**STAFF REPORT: 9/13/2023 MEETING**

**APPLICATION NUMBER: HDC2023-8524**

**ADDRESS: 4138 LINCOLN**

# 4138 Lincoln St. Renovation Historic District Commission Review

**SIDE FAÇADE (Southeast)**

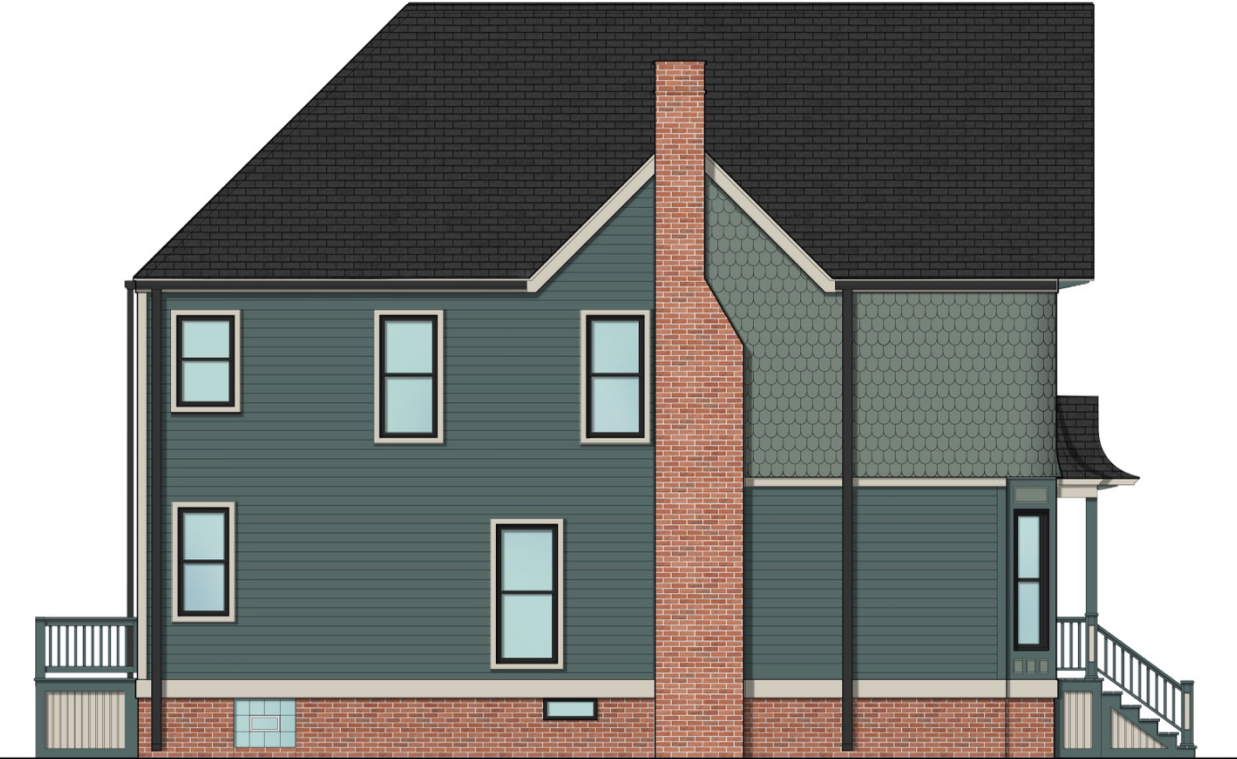
- The project includes the proposal for the erection of a new wood deck at the south side wall/side yard. It is staff's opinion that the deck as proposed is not compatible with the home's historic appearance for the following reason:
  - The south side wall is highly visible from the public right-of-way as a adjacent parcel is vacant.
  - Historically, wood porches typically included a roof overhand of some kind in order to protect the floor from deterioration due to exposure to weather.
  - The scale/ footprint of the deck is too large/wide as it extends into the adjacent lot at 4132 Lincoln. A porch at that location would have been designed to fit within the boundaries of the parcel which the house sits.

A deck of the sort proposed is better suited for the rear elevation as it would not be visible from the public right-of way. It is staff's opinion that a sensitively designed porch wood porch which includes a roof and fits within the 4138 Lincoln's parcel boundaries would be more appropriate for this location.

It is staff's opinion that the proposed new south side deck is not appropriate to the building's historic character for the following reasons:

- The south side wall is highly visible from the public right-of-way as a adjacent parcel is vacant.
- Historically, wood porches typically included a roof overhand of some kind in order to protect the floor from deterioration due to exposure to weather.
- The scale/ footprint of the deck is too large/wide as it extends into the adjacent lot at 4132 Lincoln. A porch at that location would have been designed to fit within the boundaries of the parcel which the house sits.

- The new doors proposed for the south side wall shall only be installed if an HDC approved porch is installed at that location. Also, the new doors and trim shall be wood at the exterior/not clad with metal, fiberglass, vinyl, etc., and the finish color/paint color palette of the new doors and

associated trim match that proposed for the front door/primary entrance. The applicant shall proposed a revised proposal for this door reflecting this condition to HDC staff for review and approval prior to the issuance of the project permit.
